Ten-Tec Orion/Orion II
Users Manual Addendum
Firmware Version V3

The purpose of this document is to identify the changes that were made to generate the V3 firmware builds for the Orion Model 565 and the Orion II Model 566, [Orion(s)]. The changes include new features, enhancements to existing features, and resolution of various problems. The V3 firmware is the first version to support the Model RX366 High Performance Sub Receiver. The RX366 brings a new level of performance for the Orion(s) and a competitive advantage for Contesters and DXers alike. Pictures in this addendum are from the 566. 565 differences are noted.

- To support the added filters and configuration thereof, the following menu items were added to the "**Filtr**" Menu:
        Sub-Rx Slot 1
        Sub-Rx Slot 2
        Sub-Rx Slot 3   New "**Filtr**" Menu in Orion II

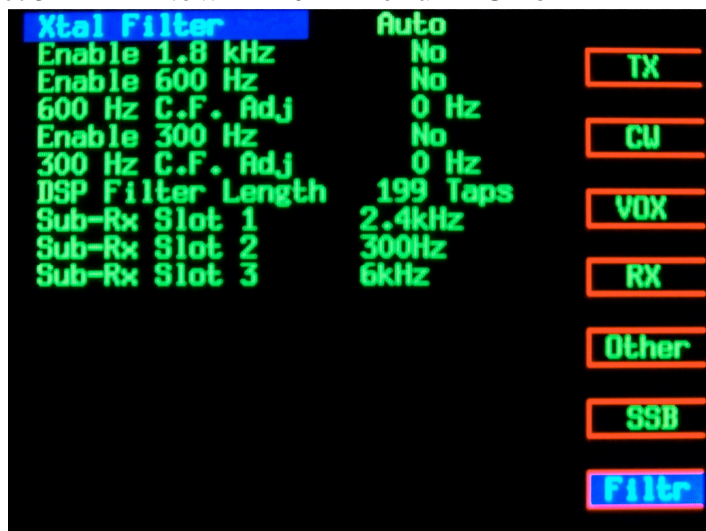
- Once the Sub-Rx Slot menu items are selected to match the actual filters installed into the RX366, the software will select the appropriate hardware filter when the Sub-RX BW is adjusted.

- If all Sub-Rx Slot menu items are None, which is also the case when either a RAM Clear or MASTER RESET has been performed, then the software will always select Sub-RX Slot 1.

New "RX" Menu in Orion II

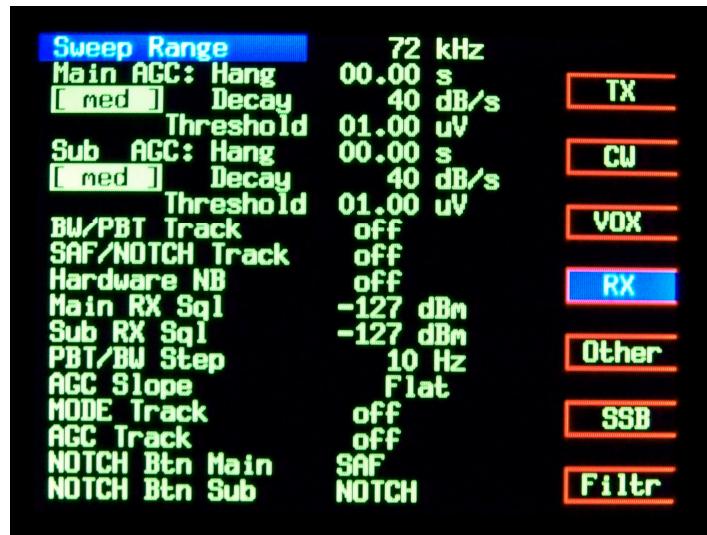
- Both the *SAF* and NOTCH receiver functions share the front panel NOTCH button to turn the feature on / off. It is therefore necessary to configure the button to control either the *SAF* or the NOTCH. The configuration is managed in the "**RX**" Menu with the addition of the following two new menu items:

NOTCH Btn Main   (selections include NOTCH or *SAF*)
    NOTCH Btn Sub   (selections include NOTCH or *SAF*)

NOTE: For the Orion 565, the two new menu items for NOTCH button usage are:
    NOTCH Button Main (selections include NOTCH or *SAF*)
    NOTCH Button Sub   (selections include NOTCH or *SAF*)

Main Receiver Display showing *SAF* enabled for MAIN

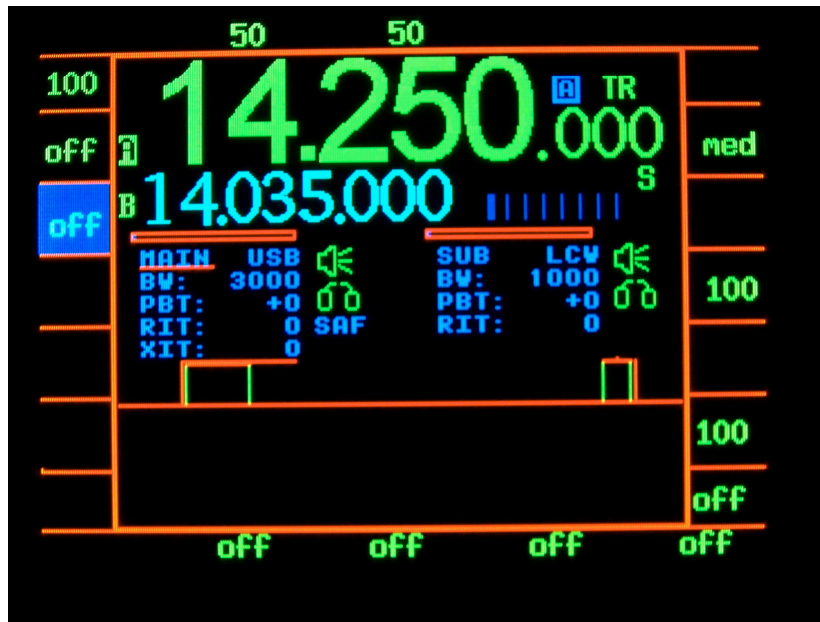
- *SAF* action per receiver is identified by the presence of the text "**SAF**" underneath the headphones for each receiver. The following picture shows how the menu selection in the previous example is depicted on the main receiver display.

- Note the text "**SAF**" underneath the main headphones. This indicates that the NOTCH button, when MAIN-RX is selected, will perform the *SAF* function. Since the NOTCH text shows off (instead of CF:xxxHz or W:xxxHz), this means *SAF* is enabled, but not functioning yet. Pressing NOTCH would then engage *SAF* filtering.

- If *SAF* had been selected for the SUB-RX, then the text "**SAF**" would have appeared underneath the Sub Headphones. Since it is not shown in the above picture, this means that when SUB-RX is selected, the NOTCH button performs the Manual Notch feature.
